PLAN REVIEW COMMENTS FOR DP-12-23-018802

Town of Bluffton

Plan Description: A request by Nathan Sturre of Sturre Engineering on behalf of the property owner Hinton Vacation Properties

MAIDEN LANE DEVELOPMENT

CONCEPT MASTER PLAN

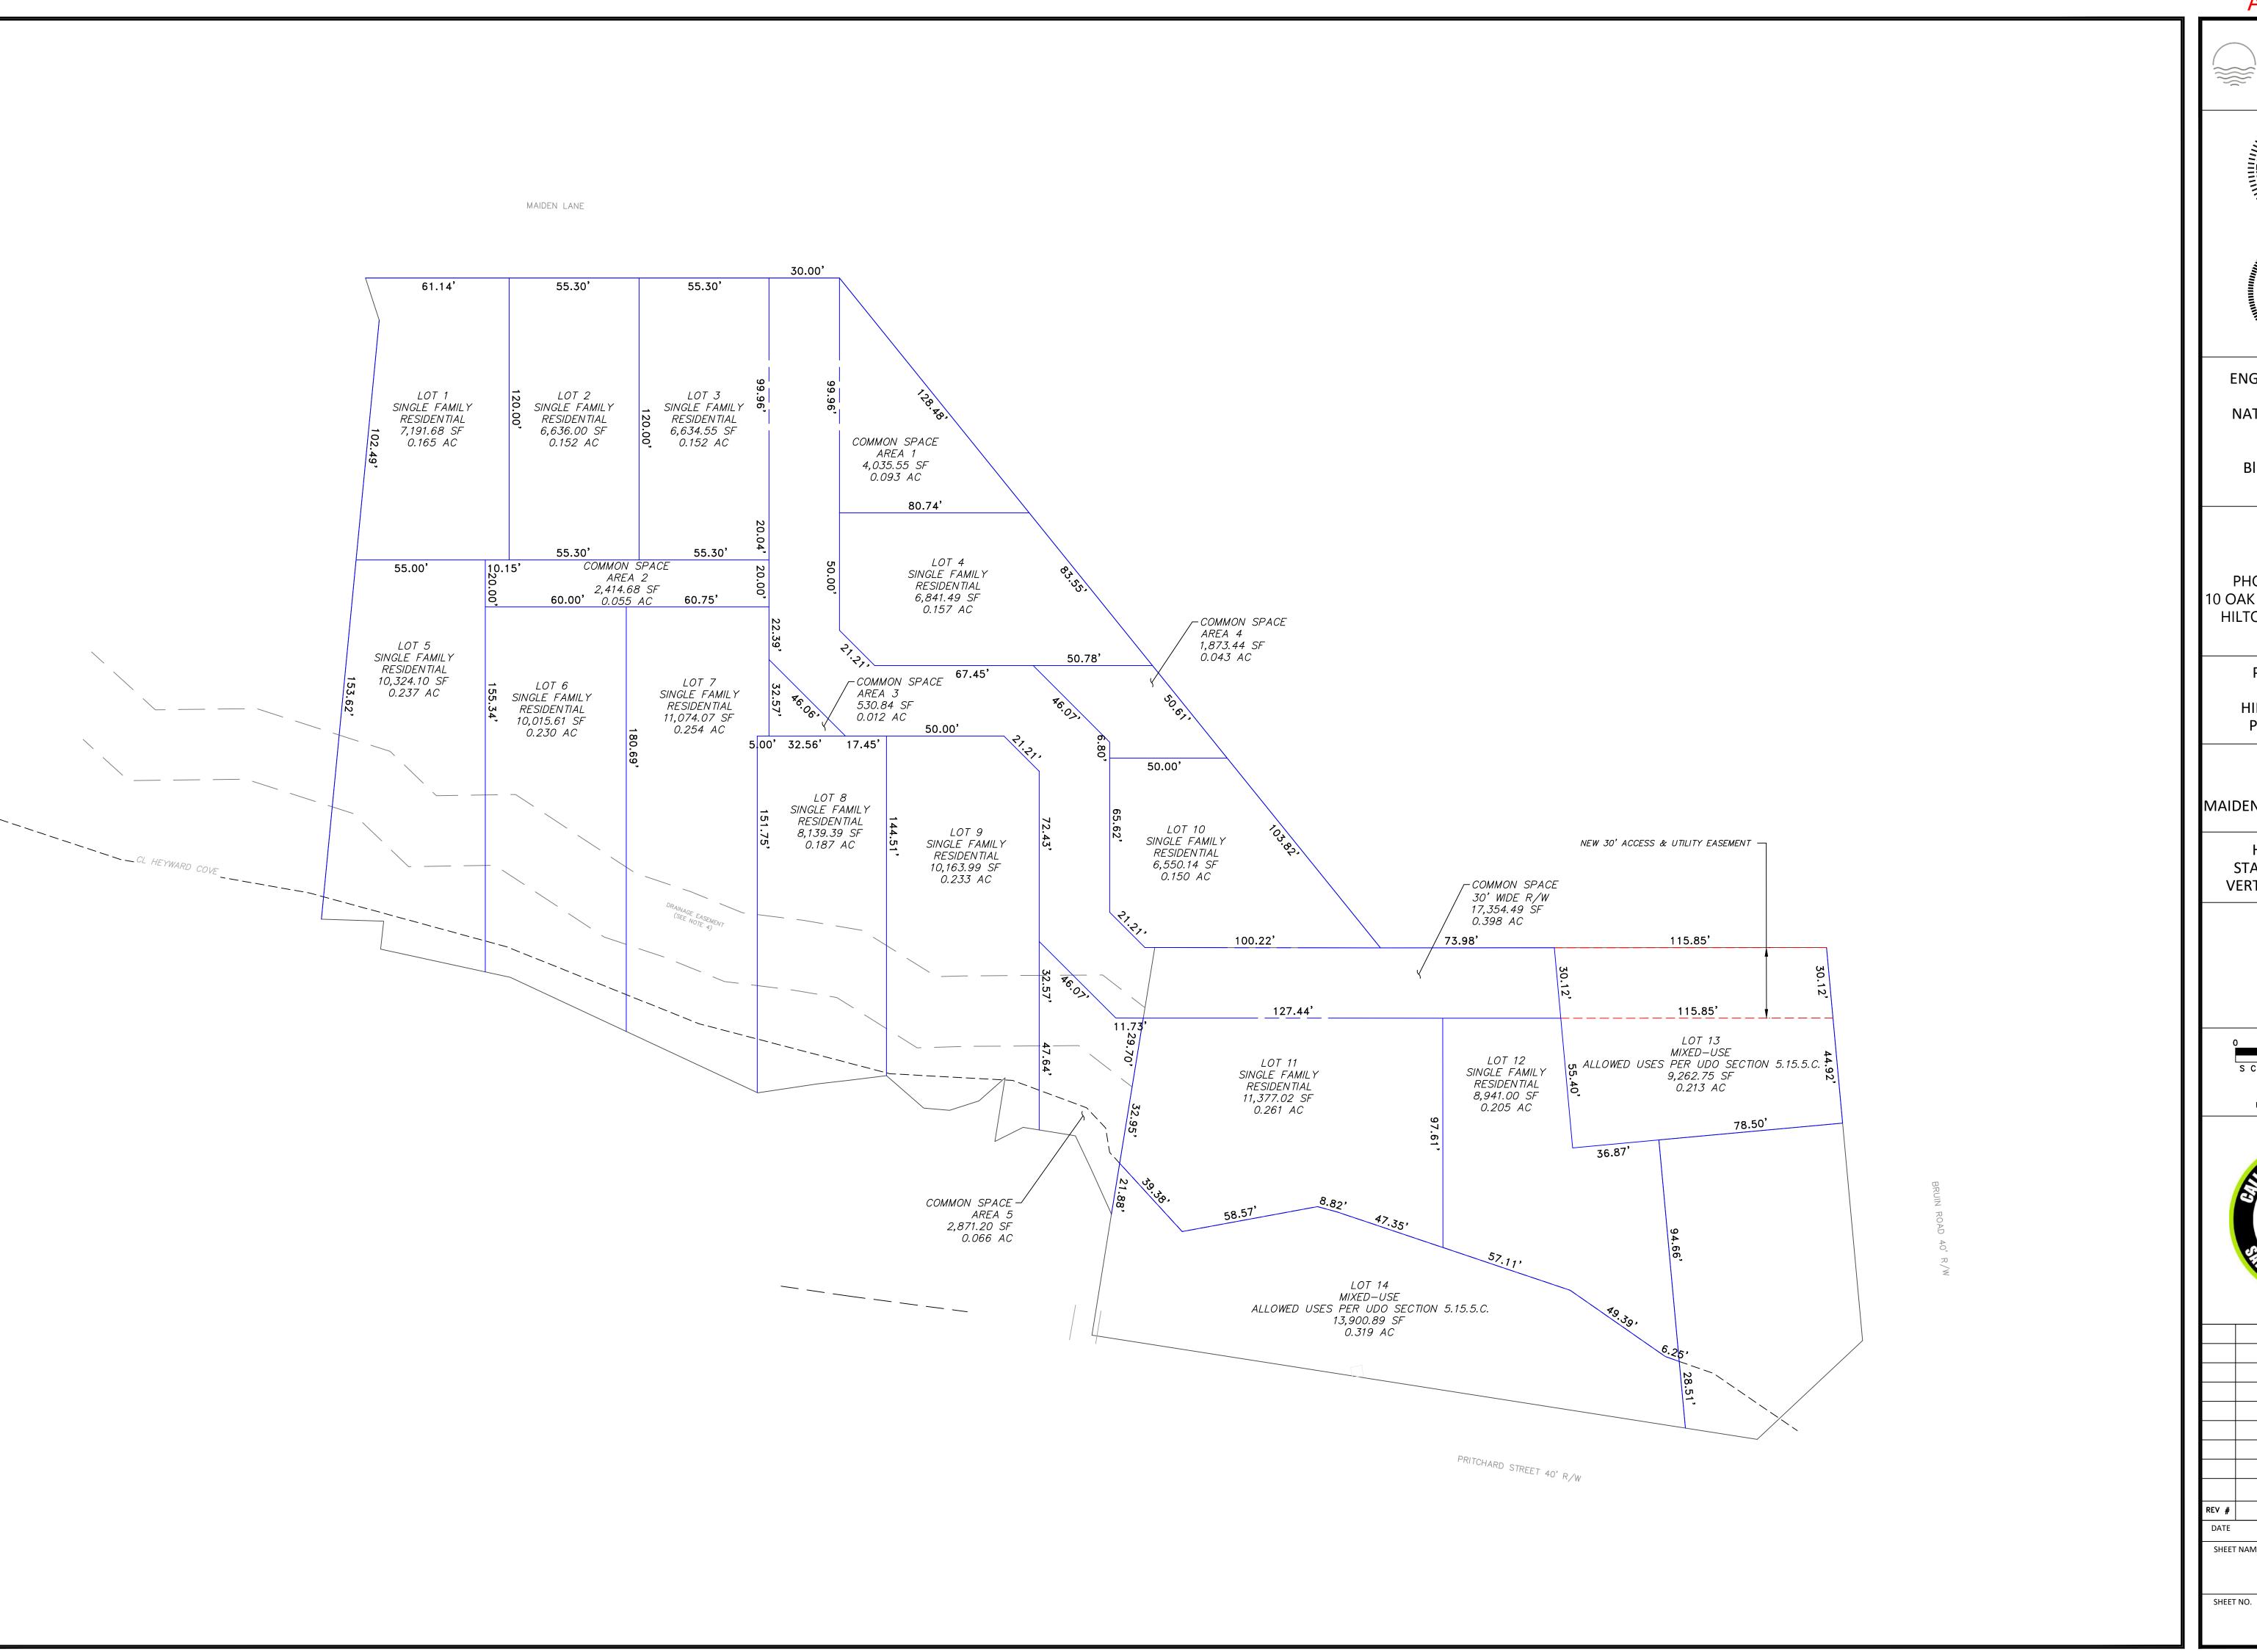
- 4. Lots 5, 8 and 12 do not meet the frontage requirements for Neighborhood General -HD General. Roads are not Common Space. Currently, the area identified as Open Space 2 is the only access to lots 5, 6 and 7, and should be identified as ROW. (UDO 5.15.5.C.)

- 4. Carriage Houses for Lots 6 and 7 appear to be over top of bank.
- 5. Parking lots are not permitted as standalone use in NG-HD. Common Space Area 1 is parking lot. Remove. (4.3)

- 8. Lot 14 is labeled as Mixed Use, however no parking is provided. This lot is likely too restricted to allow a commercial use because any required parking would need to be in a parking lot with a drive aisle, etc.

- 9. Roads and parking cannot count as open space. Common Space area 3 should be included as ROW as lot 8 does not meet frontage requirements.
- 10. Consider providing a different layout with less lots to meet UDO requirements and standards.
